The HOA team reached out to us stating there was some perceived incongruities and deficiencies with the entrance water feature. We coordinated a site visit for today. I arrived at 11:15am. The water feature was operating. Met with Mr. St. Pierre. Walked the site, inspected the pump room, the site and the following is a brief report of what was found.

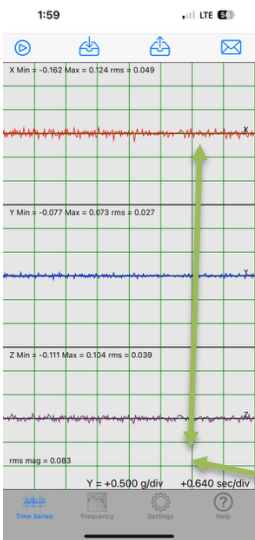
Motor – reads nearly out of spec  
Pump is fine

Motor – reads within spec  
Pump is fine

Motor – out of spec and pump unable to test.

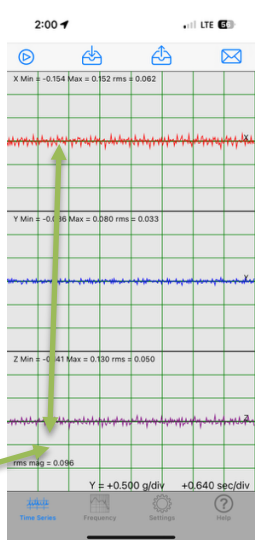
left: Pump 1: there is less than 0.25mm of vibration per second at 57hz. Shown here at 0.162mm per second. this is well within spec for the pump and motor.

right: Pump 2: there is less than 0.25.. of vibration per second at 57hz. Shown here at 0.154mm per second. Also well within spec.

BAD

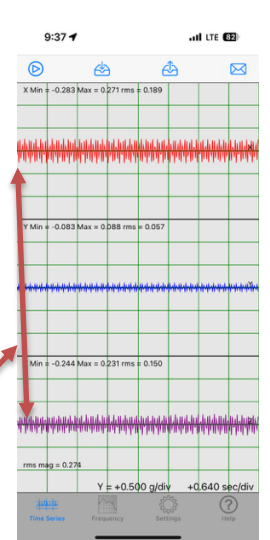
For reference... here on the right is a motor/pump that is well out of spec and shakes the entire building. The 2 Legacy at Jordan Lake Pumps I was able to test are in good working order. (ex: Barbuda Ocean Club)

P1 and P2 have stuffing boxes with graphite seals. P2 hasn't been serviced in years.

The only reason this one looks good is because it's been off for over a year.

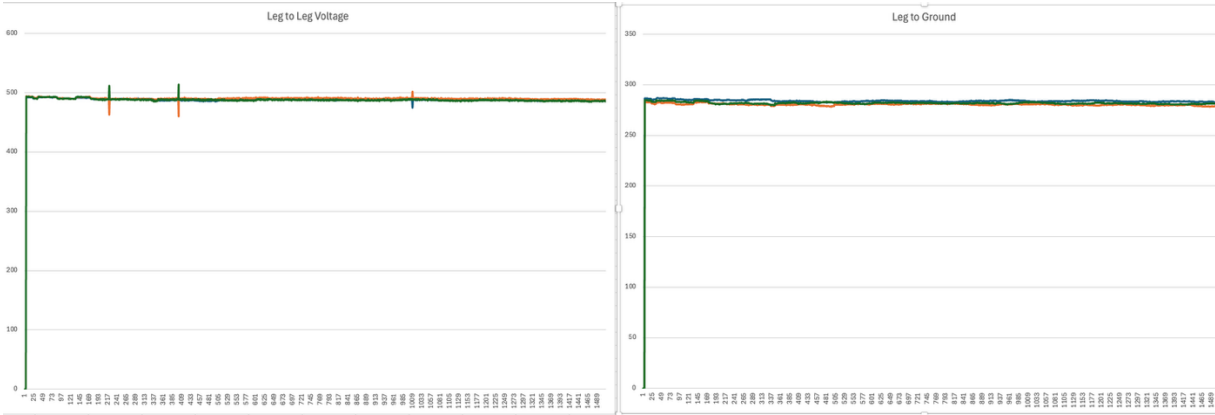
Every rear vertical coping edge on the high side of the water feature has been compromised and is eroding along the back of it. There are calcium deposit all over the face of the back walls.

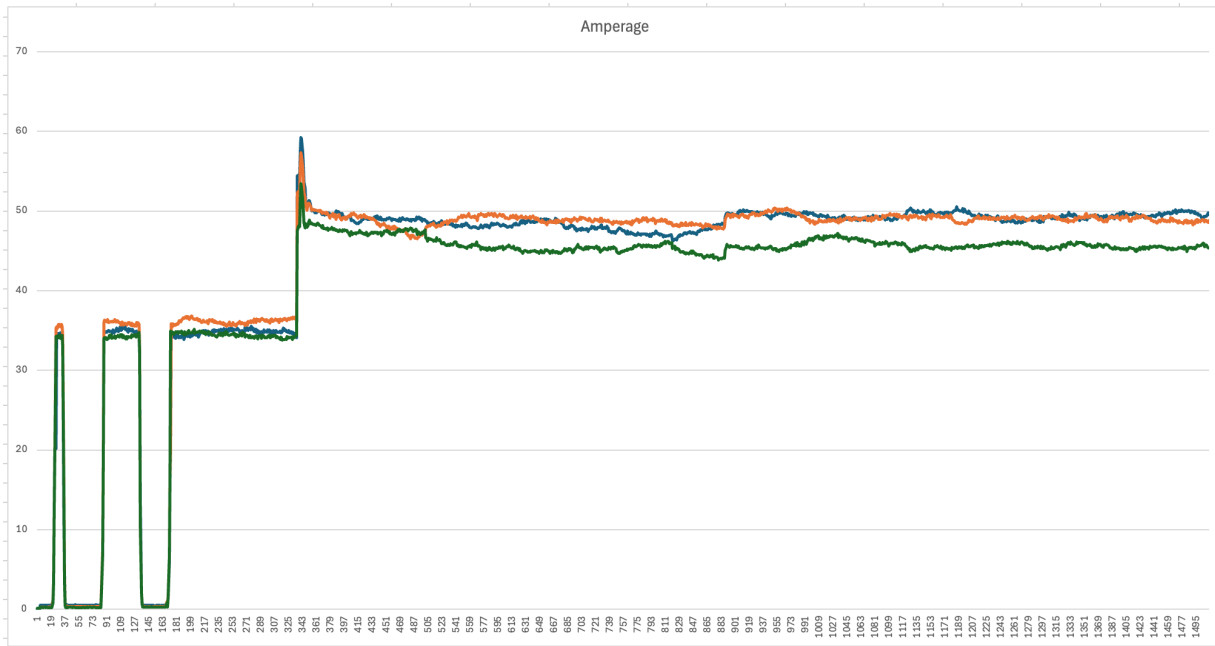
There are a few voltage spikes. If we left this device on for a few days we could probably capture an actual input phase loss. There are several on the alarm screen.

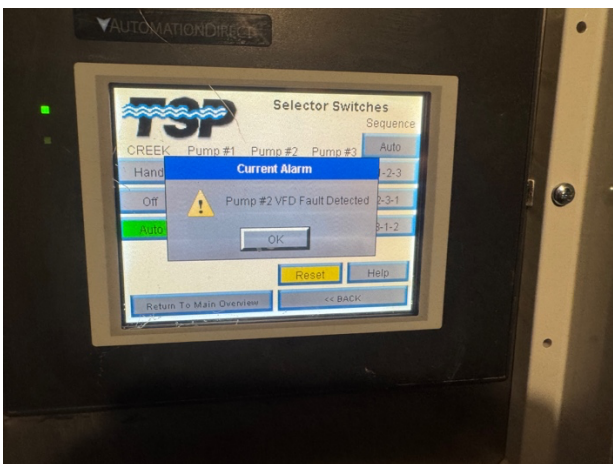
There is an amperage variance on P2. The P1 unit is well within the tolerance, the P2 motor is 15-18% out on phase C/3. This paired with not knowing how to wire the ABB VFD may be why the #2 unit was never put back in service. I just programmed it to run to 25% out of phase. Its within the VFD capabilities. But will accelerate the motor failure.
